RFI #: 45
 Date: 1/27/2012
 Job: EB-02 Keller Springs Lofts
 Phone: 877-777-5115

CC: Enviro Design Landscape
 Subject: Relocation of fountain equipment vault

RFI #: 45
 Date: 1/27/2012
 Job: EB-02 Keller Springs Lofts
 Phone: 877-777-5115

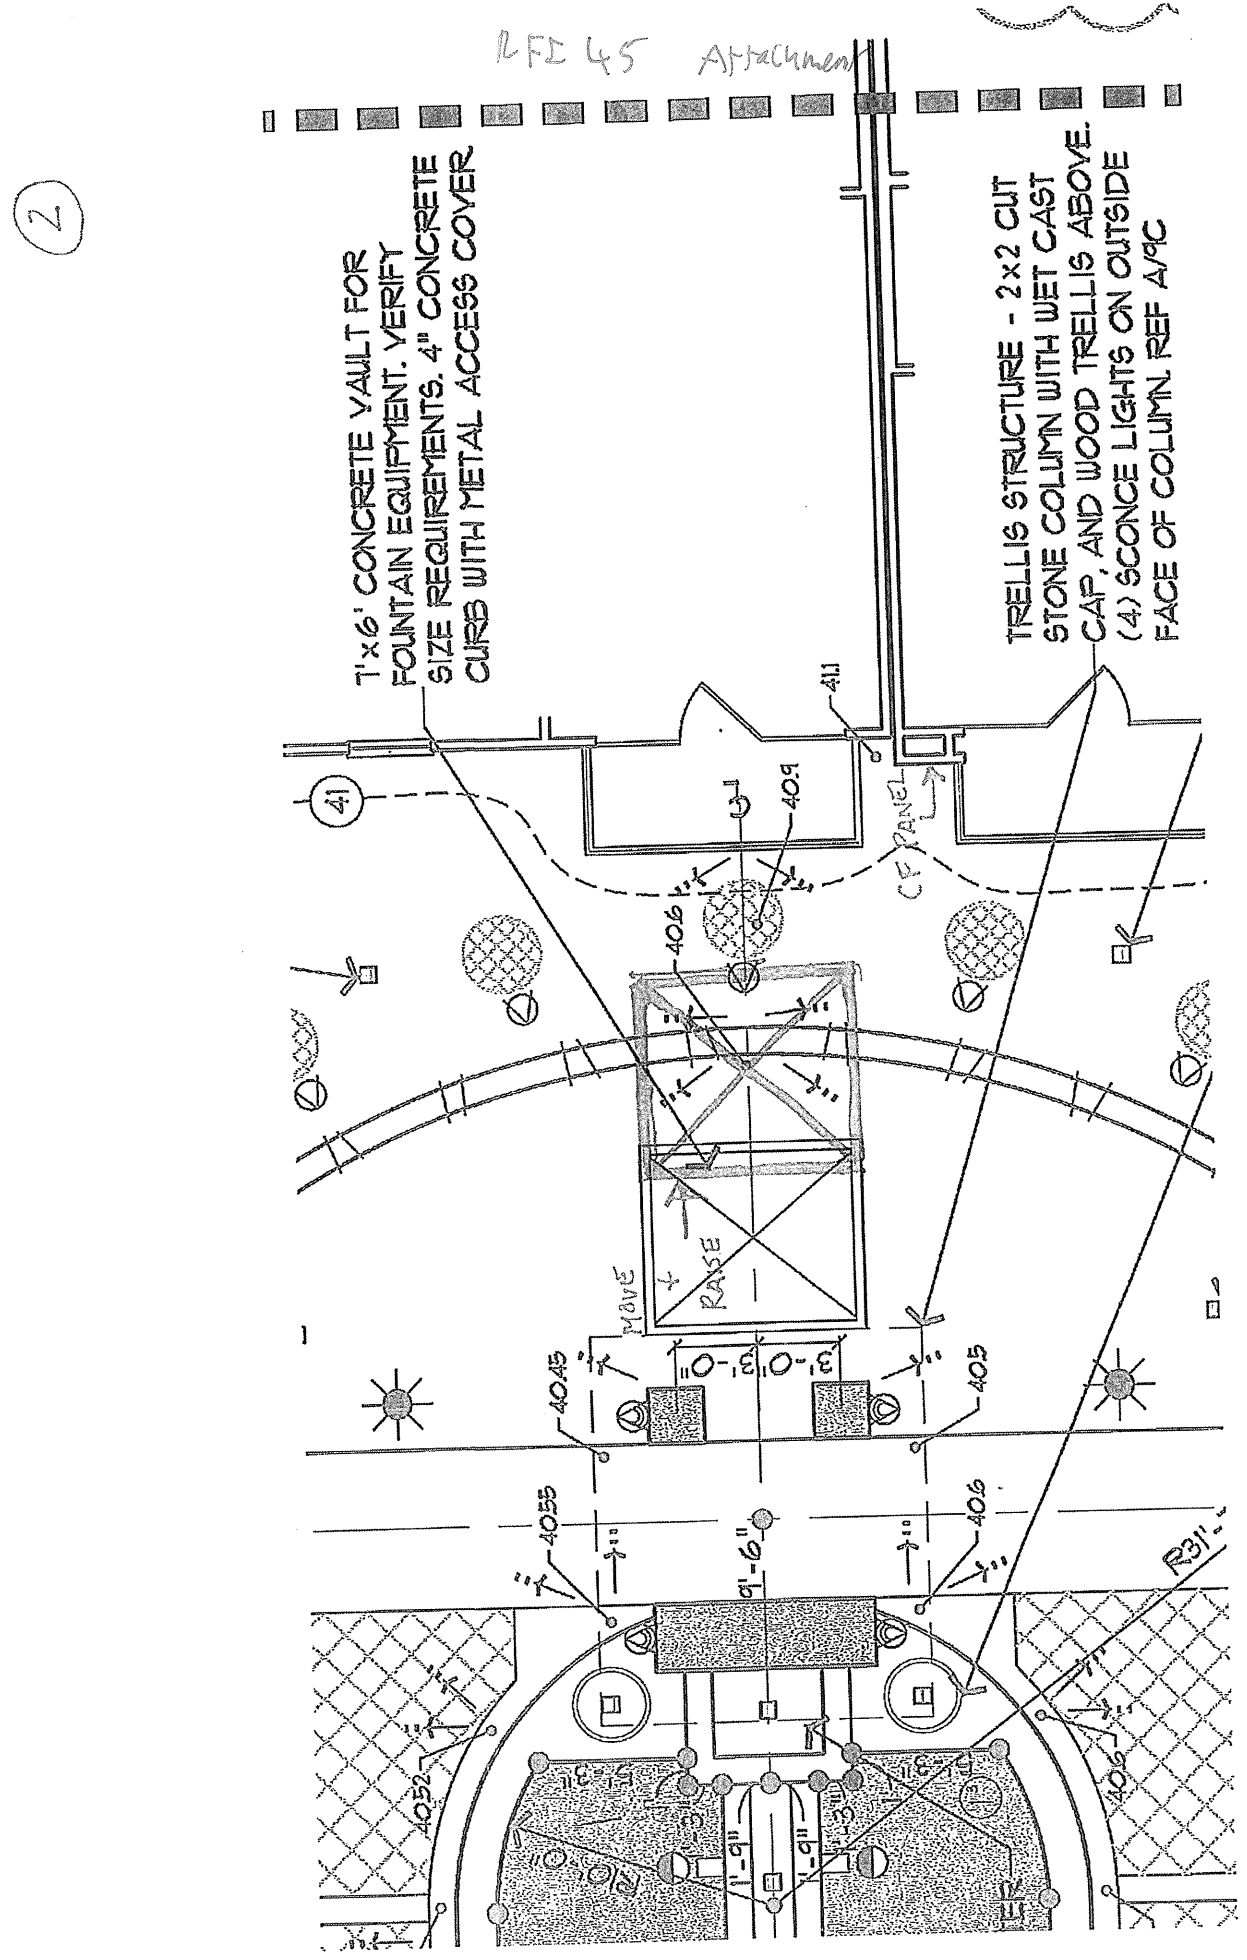
Request:
 On sheet E-1.3 on 12/21/11 a Panel 'CF' was added to the panel as a design revision. Is this for the fountain courtyard including the fountain equipment?

Sheet E-1.7 Panelboard schedule 'CF' has a note for contractor to coordinate with landscape and architect on location of 'CF' Panel. In talking with my electrician and pool contractor, we all feel the location for the CF panel should be located at the pop-out area in building between the patio's located to the southeast of the fountain equipment vault, which would be about 14' away from the power. By locating this panel in the courtyard, it would make any future changes or additions for the power requirements to the courtyard readily available.

Response: We are fine with the proposed location of the electric panel. We do have a proposed Japanese Yew that will be in conflict with the panel, so we recommend not installing the Japanese Yew and just filling the area in with Liriope groundcover.

JSE Response: Panel 'CF' serves the fountain courtyard and the fountain equipment.

Relocating the panel as noted by Enviro Design is acceptable.
 - Mike Jennings/Heath Parnell, Jordan & Skala 2/6/2012
